**FINAL PLAT
SOUTHERN HEIGHTS ADDITION
LOTS 1-7, BLOCK 1; LOTS 1-7,
BLOCK 2; LOTS 1-5, BLOCK 3
TO THE CITY OF WACO,
MCLENNAN COUNTY, TEXAS**

Purpose: Review by City of Waco.

REF.: “Final Plat of the The Final Plat of the Southern Heights Addition, to the City of Waco, McLennan County, Texas”

Project Number: 20-00046-S-SUBD

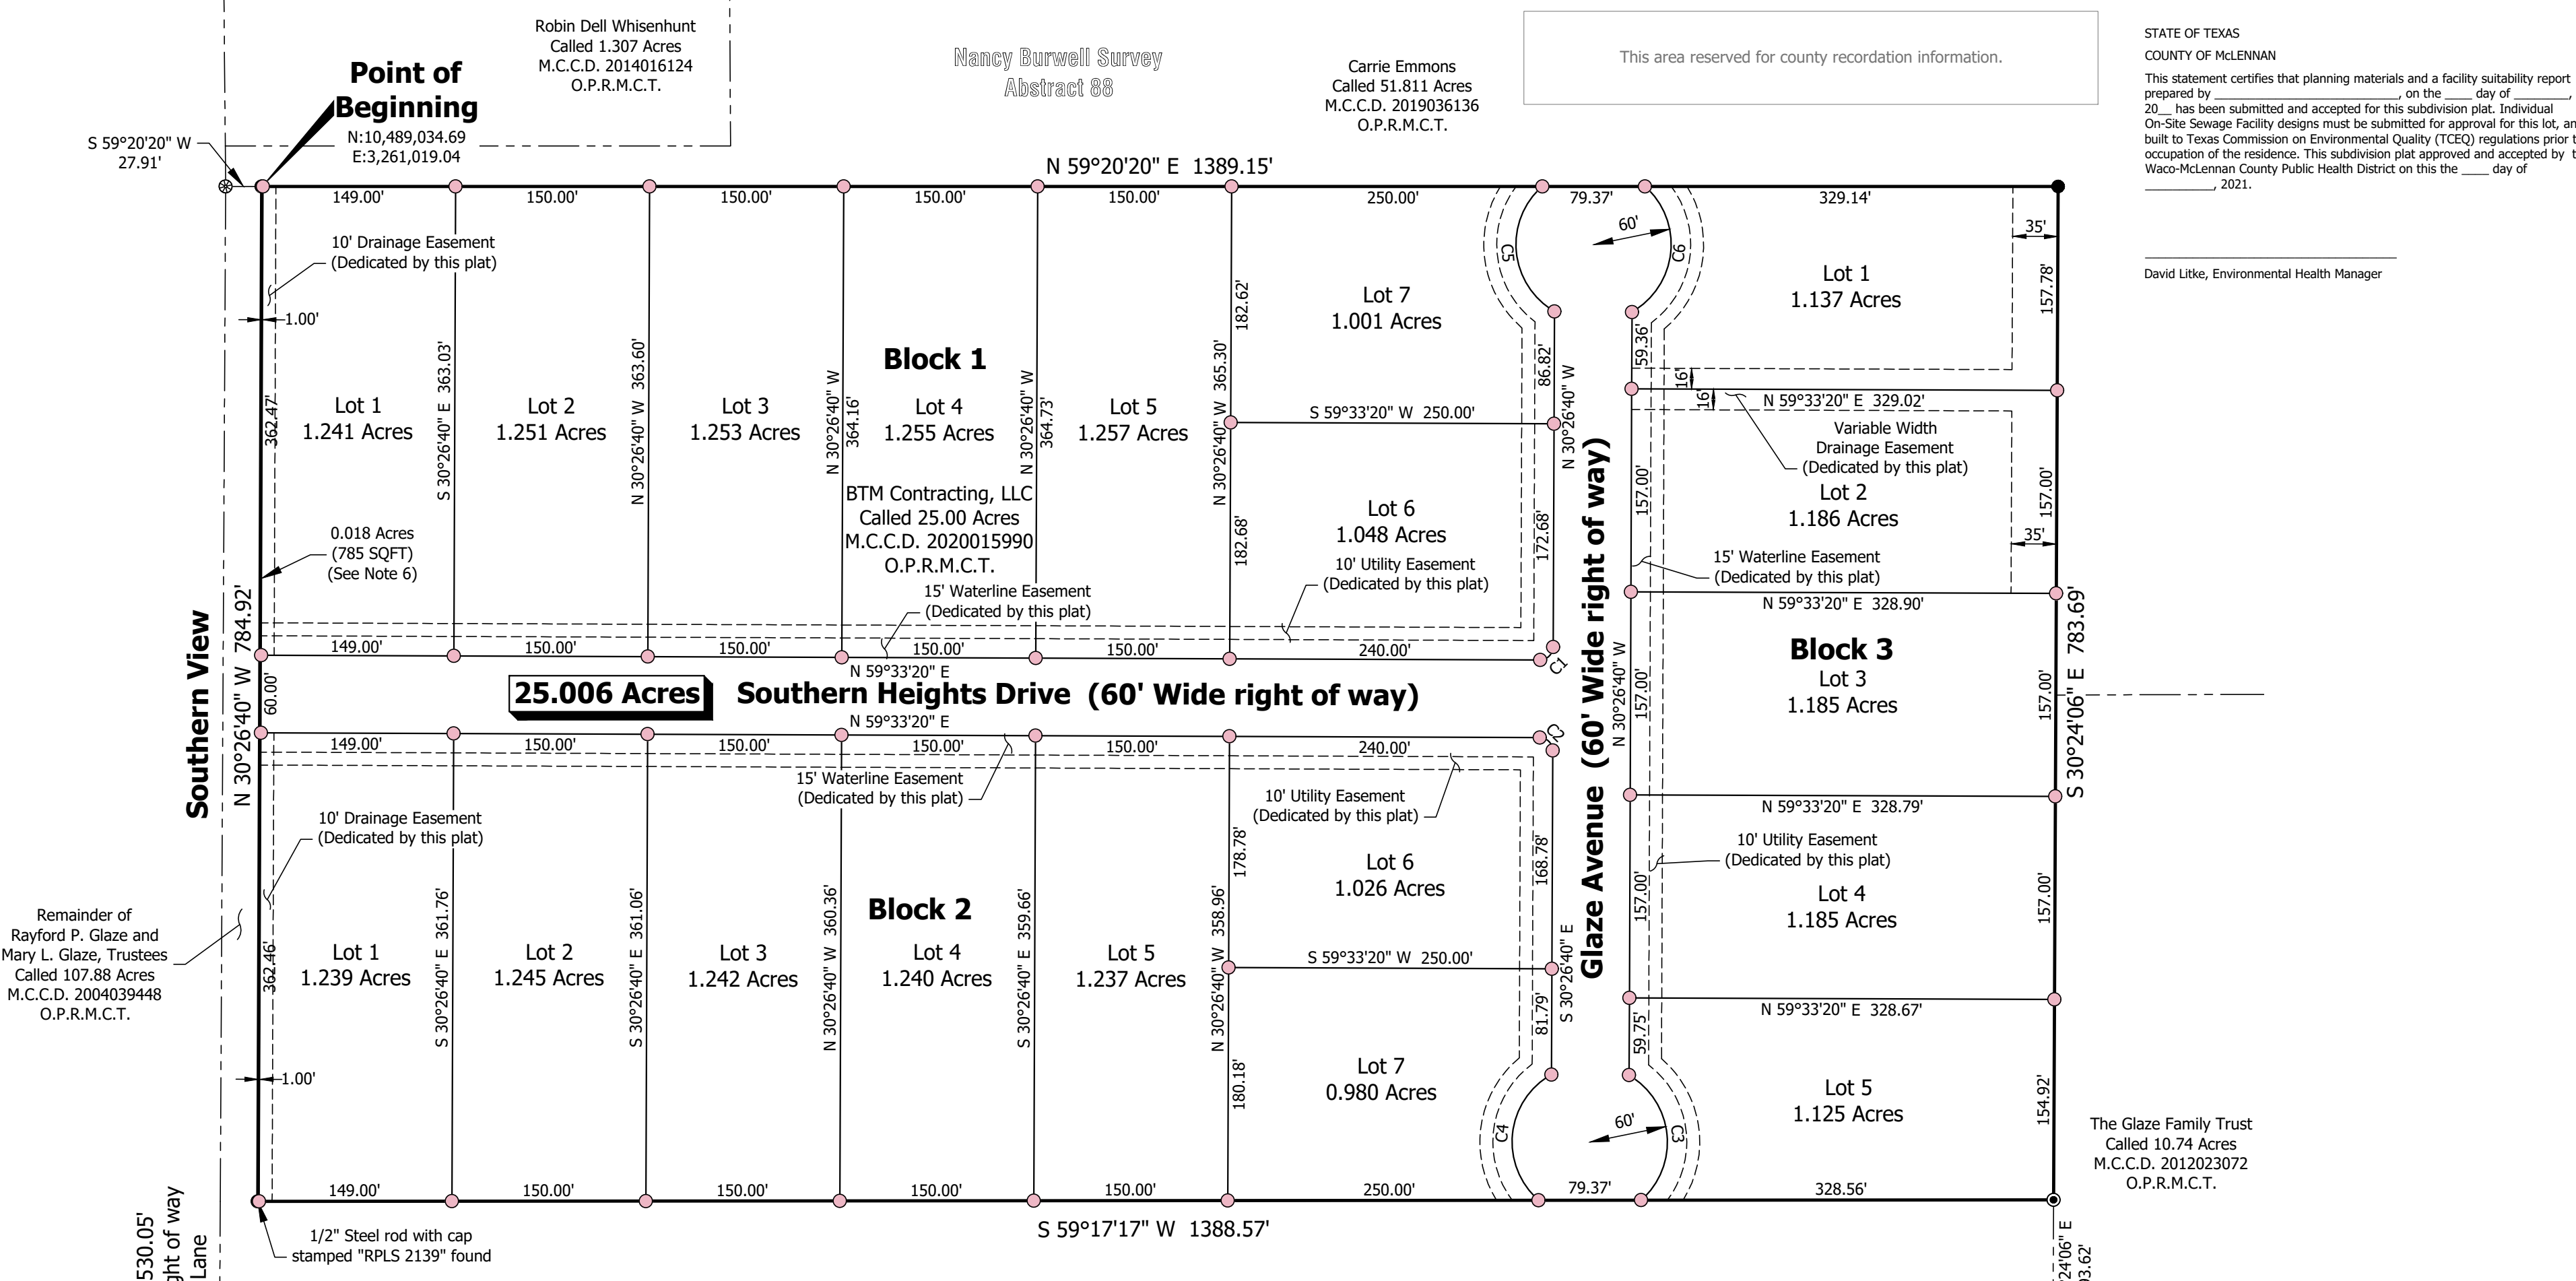
1. The owners of the property need to sign the plat. An attest signature is required with the owner’s signature. Ownership and LLC affiliation documentation required to verify the person signing the plat is authorized on behalf of the LLC.
2. The surveyor needs to sign and seal the plat and set the monuments as shown.
3. The invoice for your standard plat application is now available. Please submit a payment of \$300.00 using the Citizen Self Service online portal.
4. Please upload a current McLennan County Tax Certificate showing no taxes are due from the previous

5. Please contact Sonia Davis (sdavis@mcead911.org) for street name approval and show approved names on the preliminary plat submitted for signatures. Typically, developers are asked to submit five potential names for each street in the event the first choice is not available or approved.
6. Please submit plans for water line extension/construction via email to: AlasonD@wacotx.gov and upload them to account 20-00046-S-SUBD in the Citizen Self Service Portal.
7. Please add utility purveyors to the plat.

14. Plat and site plan provided do not match.
15. Plans for waterline extension needed for review.
